Delegated Report

Listed Building Application

Planning Application No:	20220688
Location:	Dairy Farm House, Church Street, Higham, Rochester
Description:	Application for Listed Building Consent for the proposed internal alterations to provide an ensuite bathroom at first floor level
Applicant:	Mr & Mrs David & Rebecca Martin
Site Visit Date:	Desktop assessment

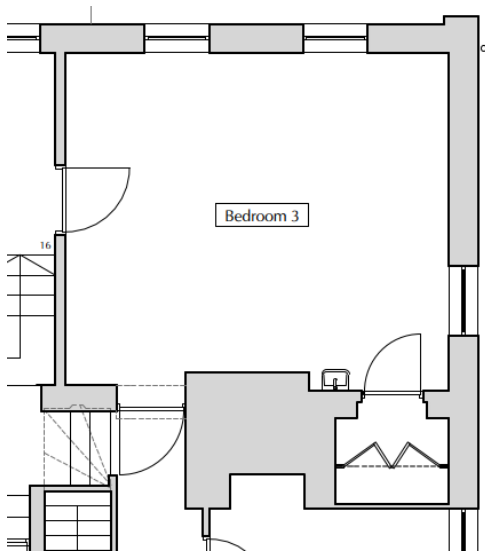
There will be no changes to the external appearance of the dwelling (other than replacing the existing diagonal drainage pipe with a 4"/110mm vertical soil pipe on the west elevation):

At present there is a sink within the bedroom with existing hot and cold-water feeds as well as a single waste pipe that traverses the west elevation (see elevation above). The latter would become redundant, being replaced by an external black soil pipe. Internally, waste pipes (for the shower and toilet) can be concealed within an existing subfloor void, access to which can be fortuitously achieved through the void above the built-in cupboard within the corner of the ground floor study (i.e. the walk-in cupboard to Bedroom 3 is located within a niche directly above this to the west side of the chimney stack.)

There are no concerns with the alteration of the wardrobe/cupboard to an ensuite. To the exterior, the replacement of the soil pipe would be negligible in terms of its impact on the listed building, though the material of the pipe should be conditioned to match the existing. In terms of the interior changes, the works will all be internal to the cupboard, including additional partitioning. This should be conditioned to ensure that the fabric of the rooms outside the ensuite are not affected.

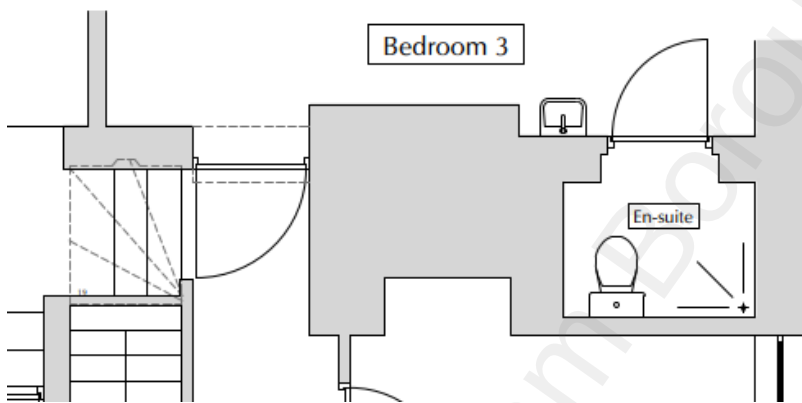
The submitted Design and Access Statement states that at present the current bathroom provision is inadequate for a family. The interior alterations seek to provide an ensuite bathroom accessed from bedroom 3 by effectively adapting the current walk-in wardrobe space.
